# Access Compliance Report

## Public Rights-of-Way

Intersection ID: 28109	Main Street: BLAKENEY_HEATH_RD	Cross Street: BORCHETTA_DR	Location:	N
ADA ID: 65E66068263A	Ramp Type: Perpendicular Diagonal	Initial Pass/Fail: Fail	Overall Compliance: No	Severity Score: 12.5

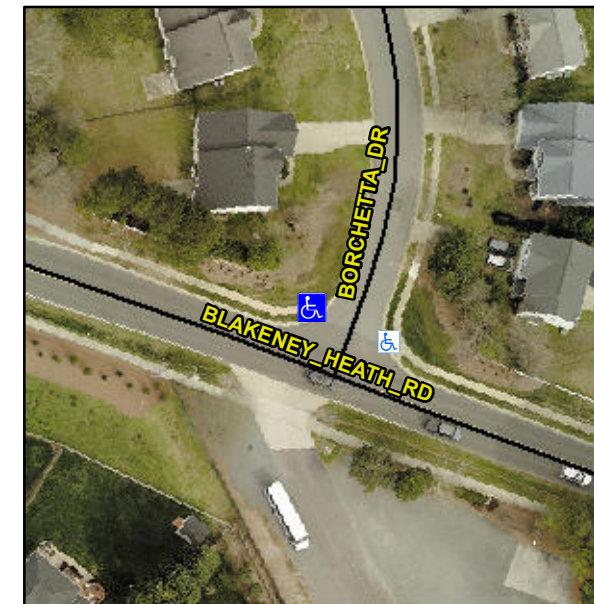
**R304.5.3**

Compliance	Description	Data	Compliance	Description	Data
N/A	Ramp Length (in)	97.0	Yes	Ramp Slope (%)	7.2
Yes	Ramp Width (in)	48.0	No	Ramp XSlope (%)	5.8
N/A	Flare Type LT	N/A	N/A	Flare Type RT	N/A
N/A	Flare Slope LT (%)	N/A	N/A	Flare Slope RT (%)	N/A
N/A	Flare Traversable LT?	N/A	N/A	Flare Traversable RT?	N/A
N/A	Landing Length (in)	N/A	N/A	DWS Provided?	N/A
N/A	Landing Width (in)	N/A	N/A	DWS Contrast?	N/A
N/A	Landing Slope (%)	N/A	N/A	DWS Length (in)	N/A
N/A	Landing X Slope (%)	N/A	N/A	DWS Full Width?	N/A
N/A	Landing Curb? (Y/N)	N/A	N/A	DWS Offset (in)	N/A
N/A	Shared Landing?	N/A			
N/A	Gutter Ponding?	N/A	N/A	Gutter Slope (%)	N/A
N/A	Gutter Lip Ht (in)	N/A	N/A	Gutter X Slope (%)	N/A
N/A	Painted X Walk1?	No	N/A	Painted X Walk2?	No
	X Walk 1 Direction	To SW		X Walk 2 Direction	To SE
N/A	X Walk 1 Width (in)	N/A	N/A	X Walk 2 Width (in)	N/A
	X Walk 1 Slope (%)	7.8		X Walk 2 Slope (%)	1.3
	X Walk 1 X Slope (%)	0.5		X Walk 2 X Slope (%)	9.4

**Remove & Replace Curb Ramp With Two New Directional Ramps or Equivalent.**
